Registry No. H12063

General Locality Chatham Strait

Sublocality Southern Tebenkof Bay

Revisions and Corrections Compiled During Office Processing and Certification

Figure 18: Example of acoustic shadow creating holiday in northern pass of Windfall Islands has the least depth represented.

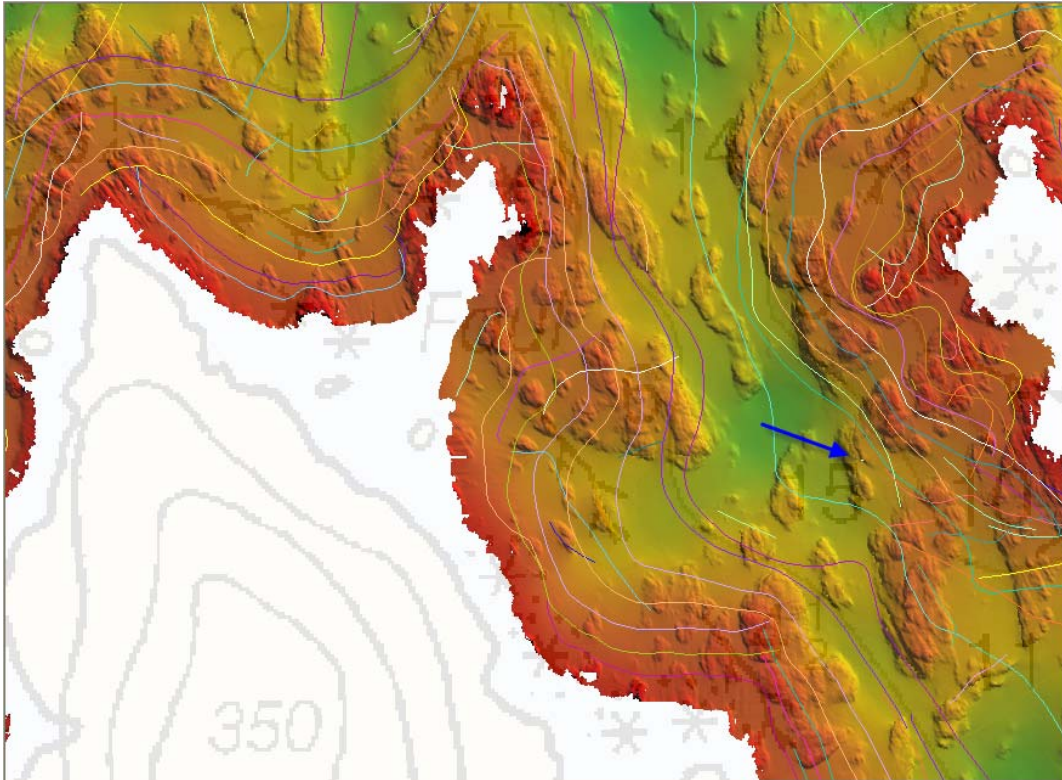
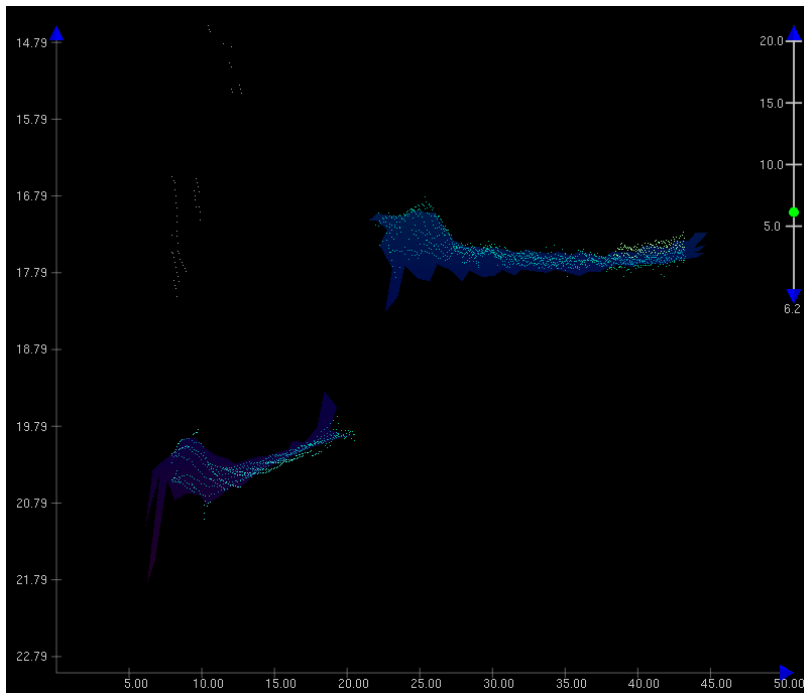
Several small acoustic shadow holidays created from beams not reaching downslope of features were created predominantly in the zero to 22 meter depth range on the eastern portion of H12063.¹⁶ See Figure 18 and 19 for example.

¹⁶ Concur with clarification. Due to the fact the holidays are on a slope and there was shoaler data acquired upslope of the holidays, the holidays are navigationally insignificant at chart scale.

Figure 21: Disagreement between charted depths (17376) and surveyed soundings in the center of Explorer Basin.

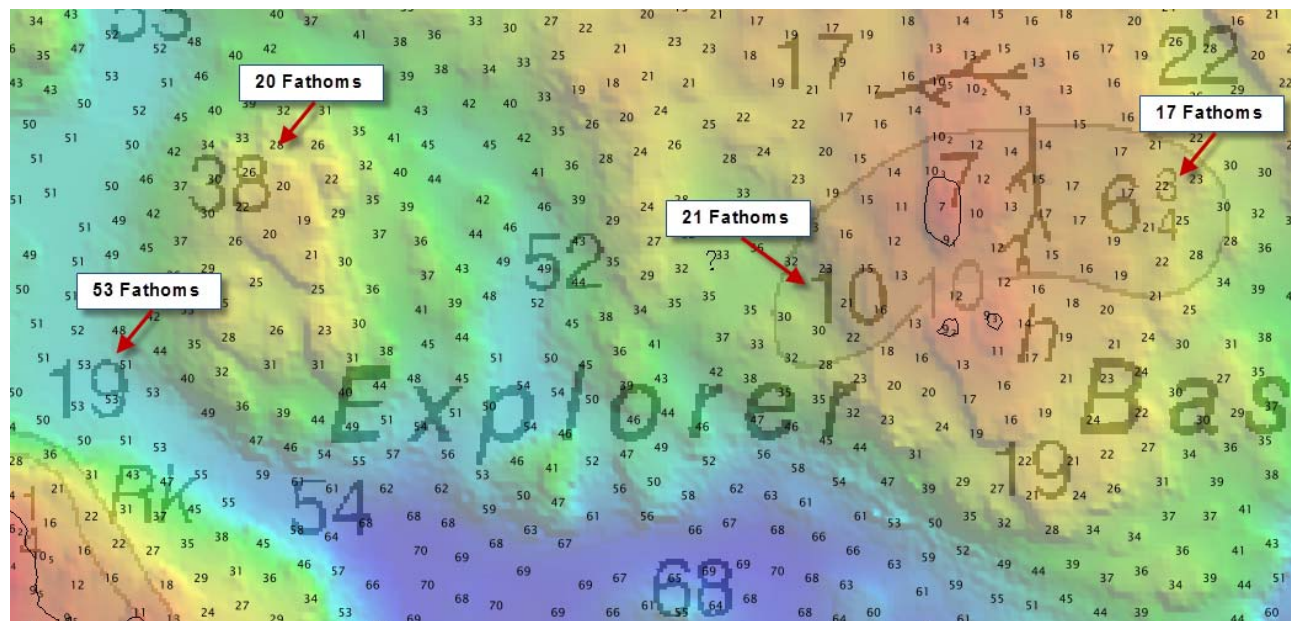
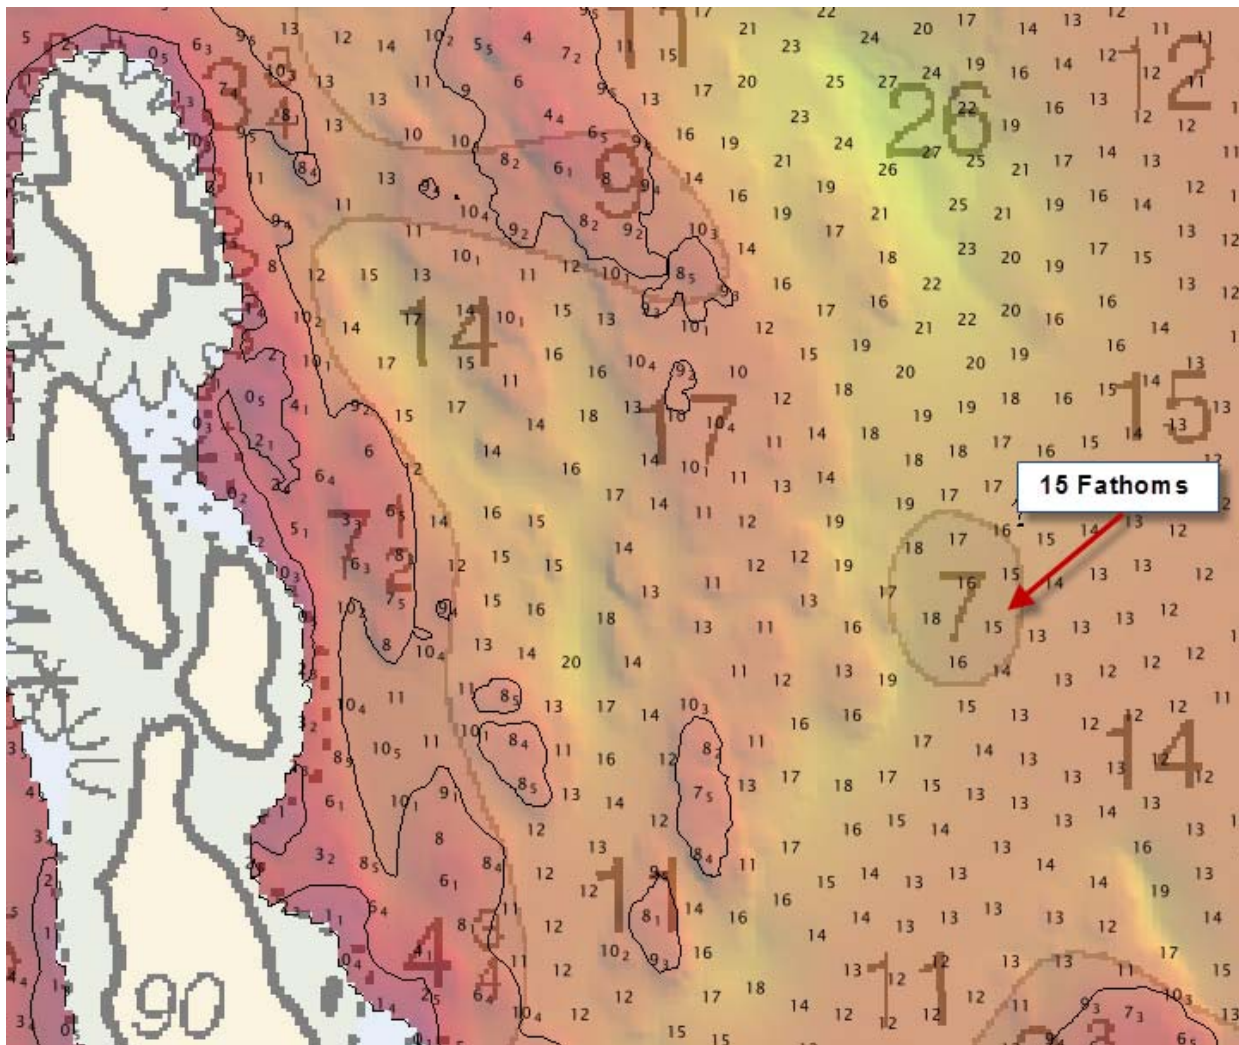
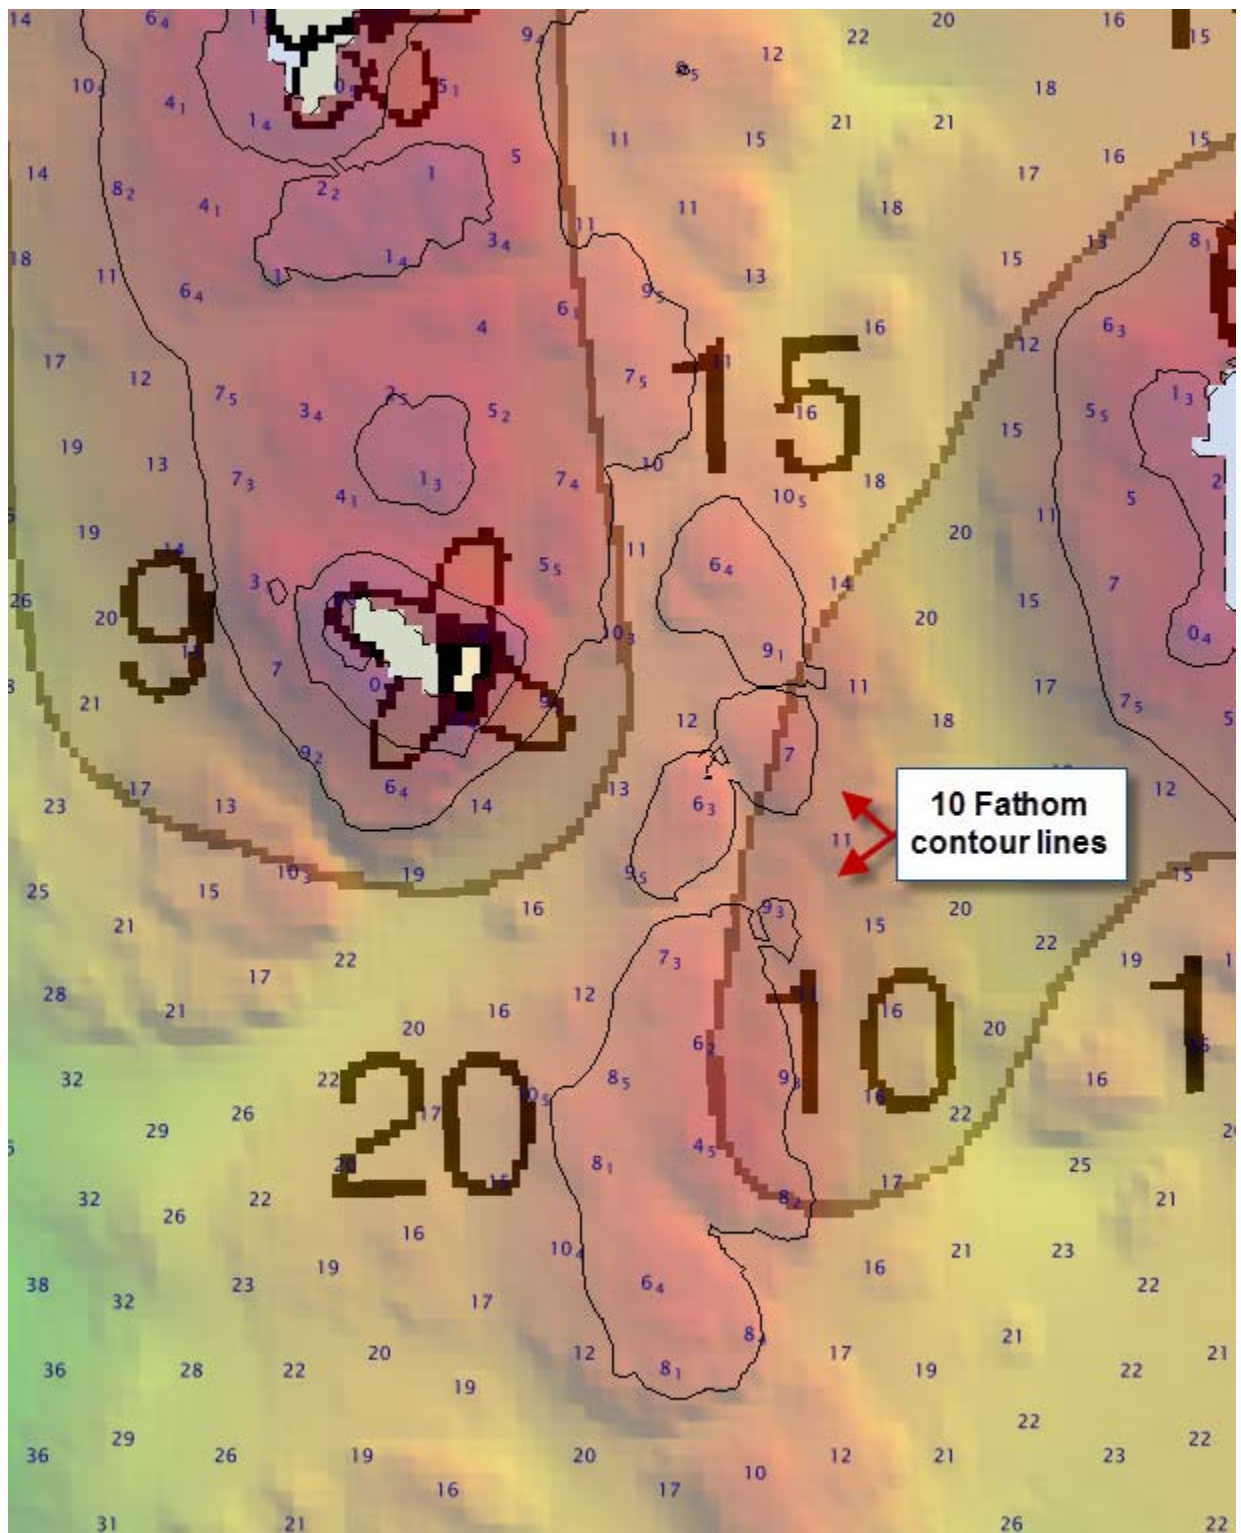
Recommendation: Soundings from survey H12063 generally do not agree within one to two fathoms with charted depths on chart 17376 and contours generated in CARIS HIPS vary generously from the charted three and ten-fathom contours.²³ Throughout the survey there are numerous rocky shoals that are not depicted accurately by the charted depths and contours. Some examples are listed and shown in the figures below. Center of Explorer Basin: a 10-fathom contour surrounds a 10-fathom charted depth with a surveyed sounding of 21-fathoms and a 6 3/4-fathom charted depth with MBES soundings at 17-fathoms (Figure 21). West off the entrance of Petrof Bay: a 10-fathom contour and 7-fathom charted depth was surveyed with MBES at 15-fathoms with no soundings less than 10-fathoms in the area (Figure 22). Southwest of Step Island: 10-fathom contour lines vary generously from surveyed MBES contour lines (Figure 23).

²³ Concur with clarification. Chart depths as depicted in the HCell and update contours based on the new survey data.

Figure 24: Disagreement between charted depth (17320) and surveyed soundings mid Thetis Bay.

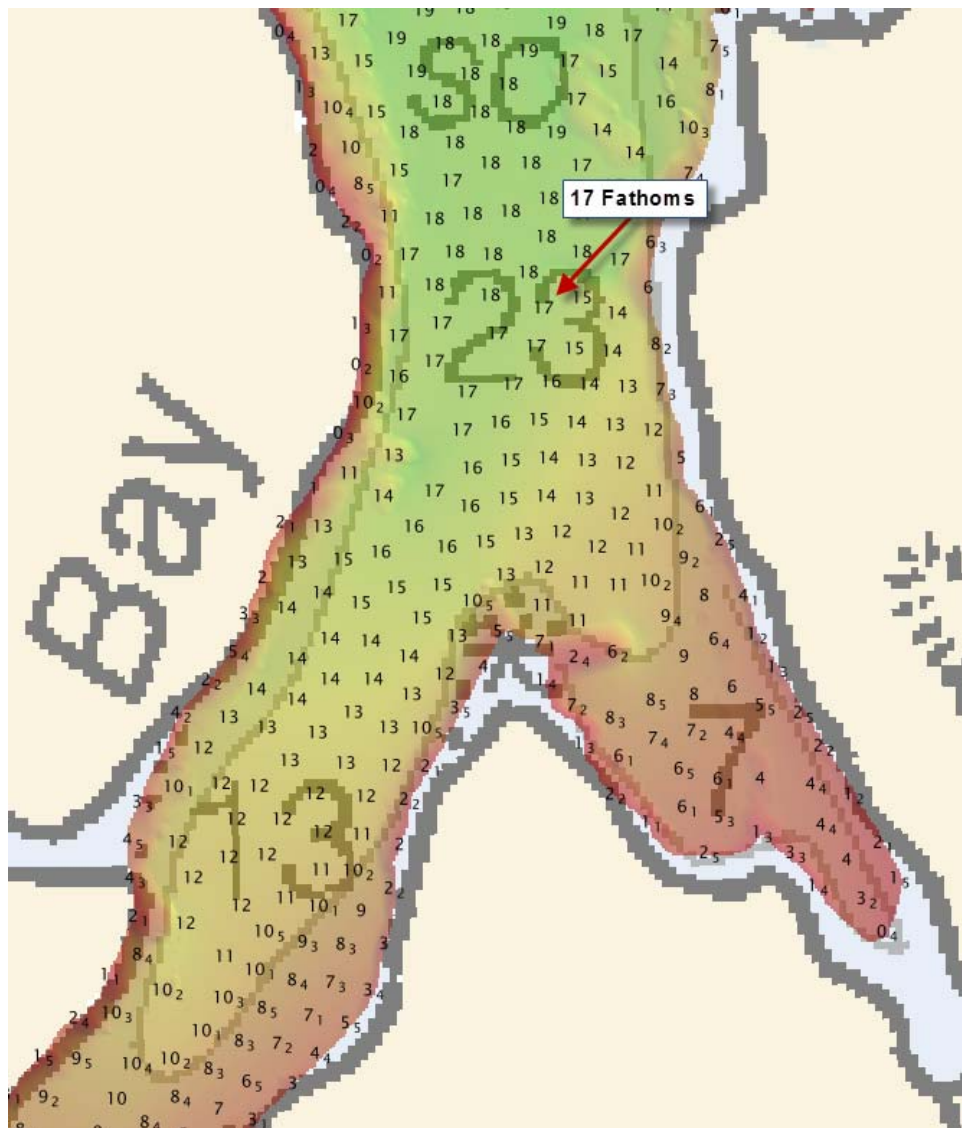
Recommendation: Soundings from survey H12063 generally agreed within one to two fathoms with charted depths on chart 17320. A notable exception to this general agreement is listed and shown in Thetis Bay (Figure 24). A 23-fathom charted depth was surveyed by MBES at 17-fathoms.²⁴ Contours generated in CARIS HIPS closely approximated the charted 3 and 10 fathom contours. Throughout the survey there are numerous rocky shoals that are not depicted accurately by the charted contours.²⁵

²⁵ Concur with clarification. Update contours based on the new survey data.

Figure 25: Disproved, by MBES foul ground areas to west of Lisa Pt and between islets, southeast of green day marker "3".

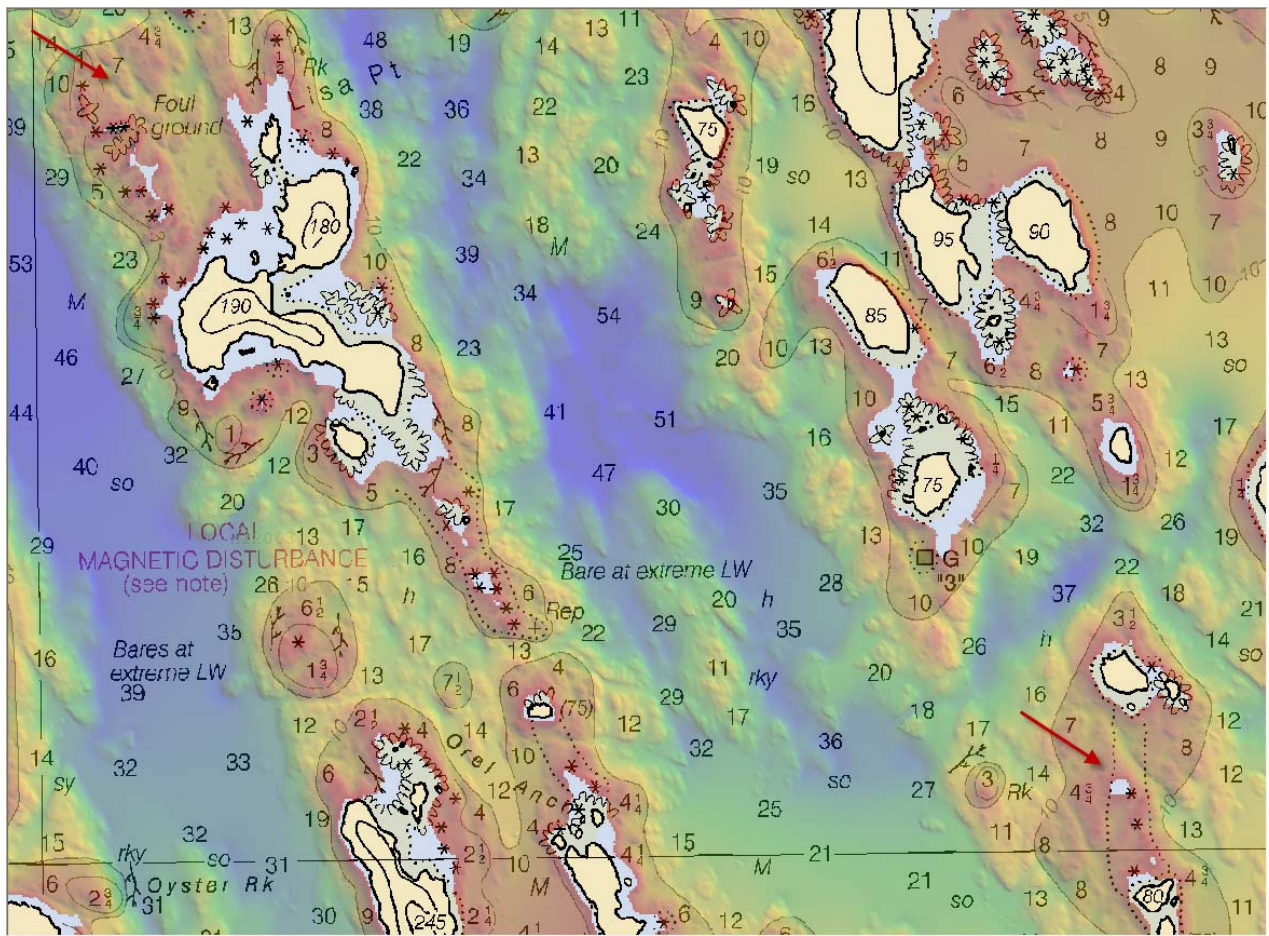
Examples of major discrepancies disproved by MBES are the foul ground areas, west of Lisa Pt, as well as the foul ground area between islets, southeast of green day marker "3" (Figure 25).²⁸

²⁸ Both the foul ground area west of Lisa Pt and the foul area between the islets southeast of green daymarker “3” have been blue noted to be removed. Chart features and depths as depicted in the HCell.

Figure 26: Reported 15-fathom sounding disproved by MBES N of Helianthus passage.

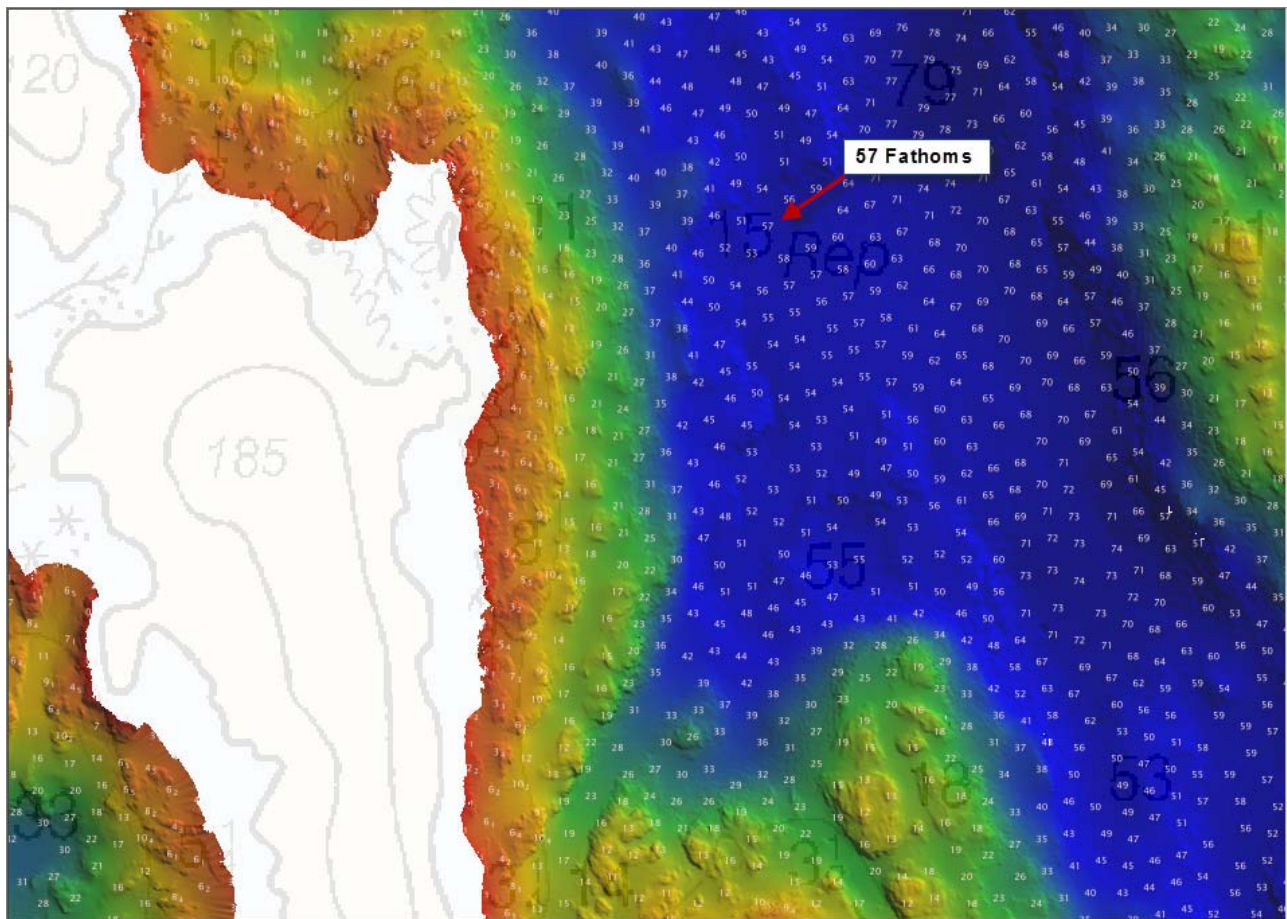
The 15-fathom sounding reported N of Helianthus passage was surveyed by MBES at 57 fathoms (Figure 26).²⁹

²⁹ The 15 fathom reported sounding has been blue noted to be removed. Chart depths as depicted in the HCell.

Figure 27: Half-meter high meter crescent shaped features observed in western side of Petrof Bay MBES.

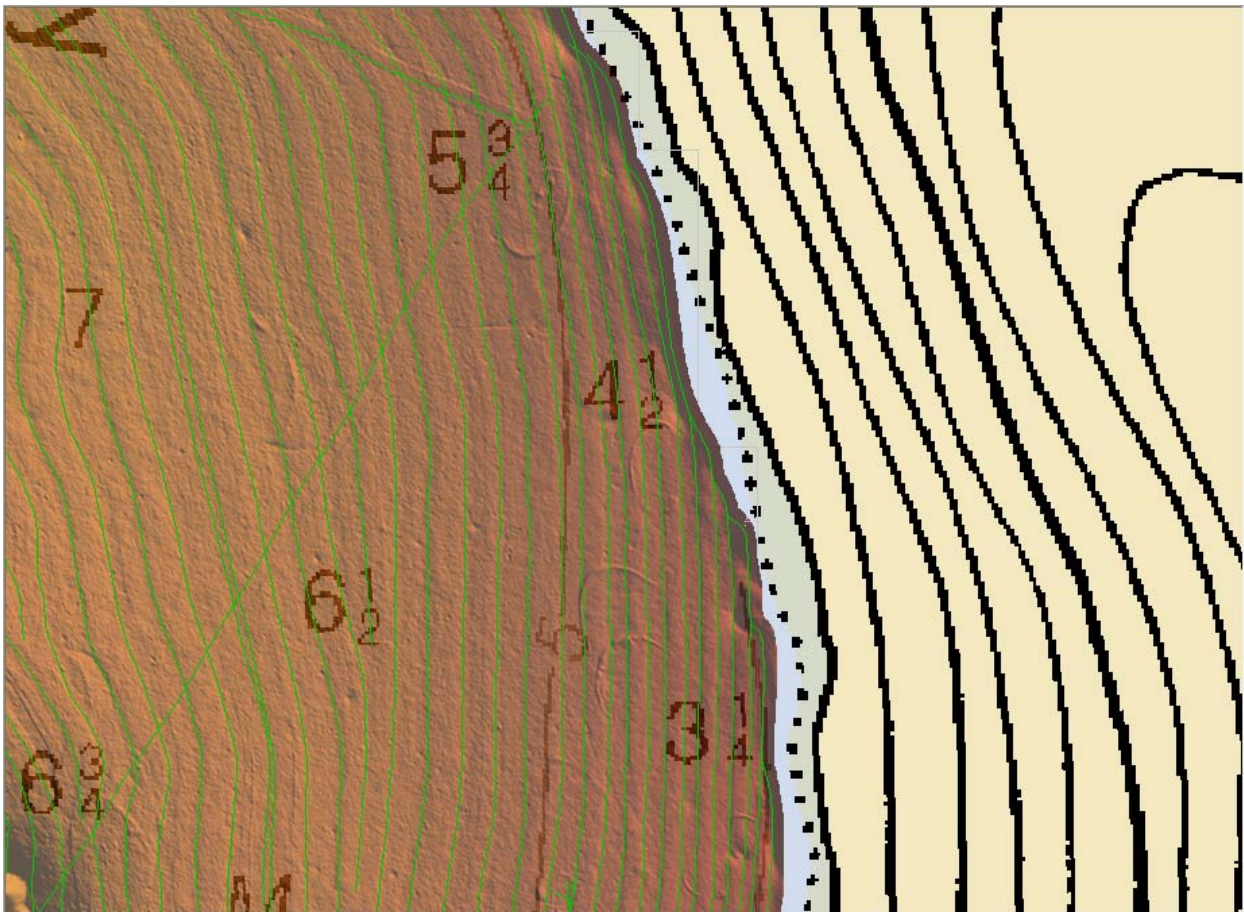
On western side of Petrof Bay crescent shaped features were observed in MBES data; these features are approximately 50cm proud of the bottom (Figure 27).³⁹

³⁹ These features are not navigationally significant. Chart depths as depicted in the HCell.
